| **AVR DEMO CABINET** | SCALE 1:12 (A4) | SHEET 1 OF 3 |
| GENERAL ARRANGEMENT | UNITS mm | REV B · 11 NOV 2026 |

| **AVR DEMO CABINET** | SCALE 1:6 (A4) | SHEET 2 OF 3 |
| RACK FRONT | UNITS mm | REV B · 11 NOV 2026 |

**RACK FRONT ELEVATION**

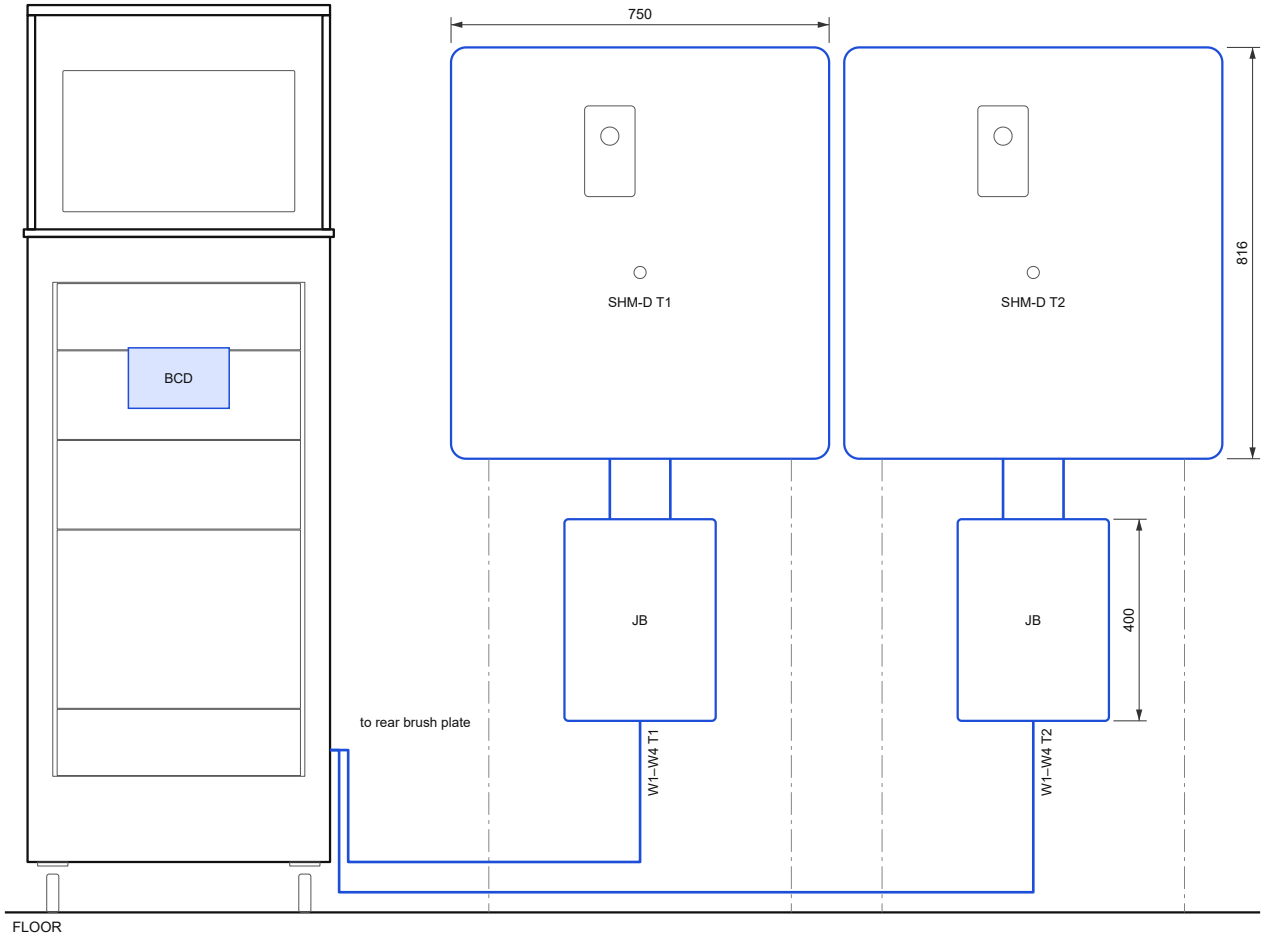
**Rev B changes**

Grid source removed.

Tap-changer simulator 4U → 3U.

HMJK-II × 2 added, upright on one 8U plate.

Rack 20U → 22U, top 1160 → 1250 mm;

fascia vents dropped, side louvres vent.

Front U20 brush panel moved to the back.

BCD box added inside, on the back panel.
